The enclosed Traffic Operational Analysis (TOA) review letter for the proposed **Lincoln Center** (Tax Parcel: 10-033.00-040) mixed-use development has been completed under the responsible charge of a registered professional engineer whose firm is authorized to work in the State of Delaware. They have found the TOA to conform to DelDOT's Development Coordination Manual and other accepted practices and procedures for such studies. DelDOT accepts this letter and concurs with the recommendations. If you have any questions concerning this letter or the enclosed review letter, please contact me at (302) 760-2124.

RE: Agreement No. 1945F  
Project Number – T202069012/PO#611882  
Traffic Operational Analysis Services  
Task 11-5A – Lincoln Center TOA

Johnson, Mirmiran, and Thompson (JMT) has completed a review of the Traffic Operational Analysis (TOA) for the Lincoln Center development, which was prepared by Landmark Science & Engineering, dated April 2022, last revised September 2022. This review was assigned as Task Number 11-5A. The report is prepared in a manner generally consistent with DelDOT's *Development Coordination Manual*.

**Site Map**

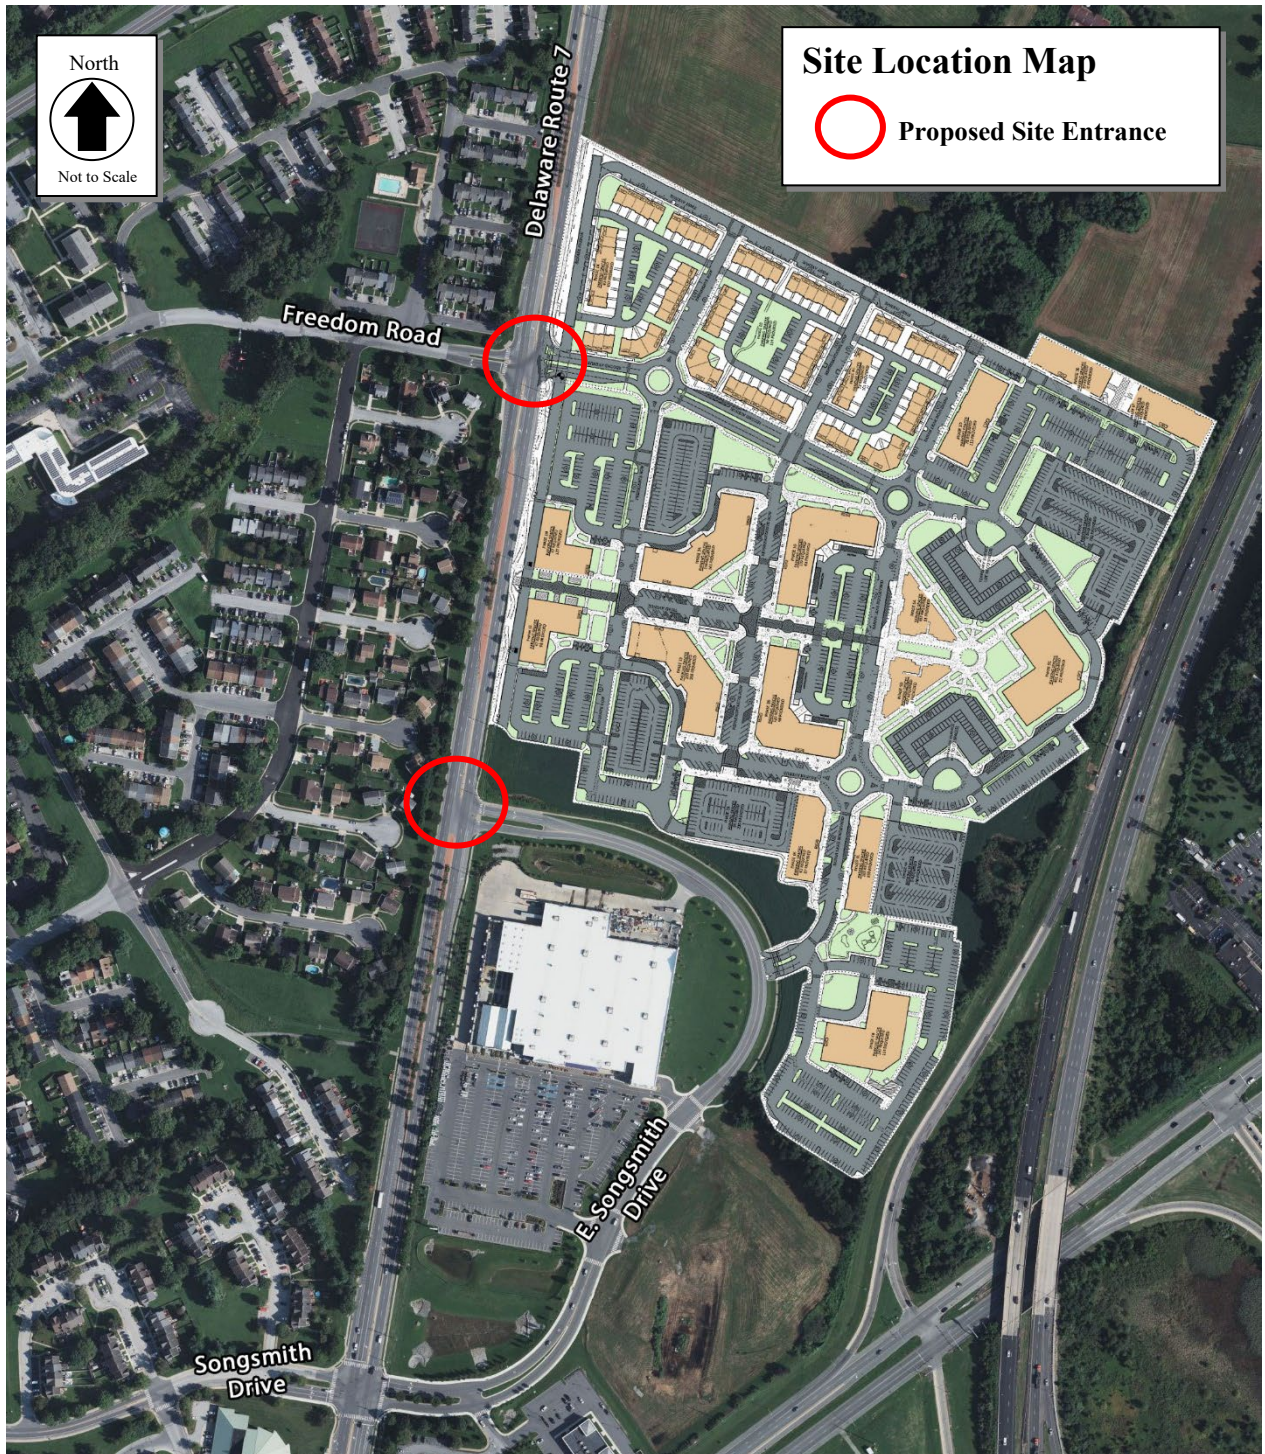
**Proposed access locations:** Two full access points are proposed on Delaware Route 7: one full access point opposite Freedom Road and another by way of a connection with E. Songsmith Drive.
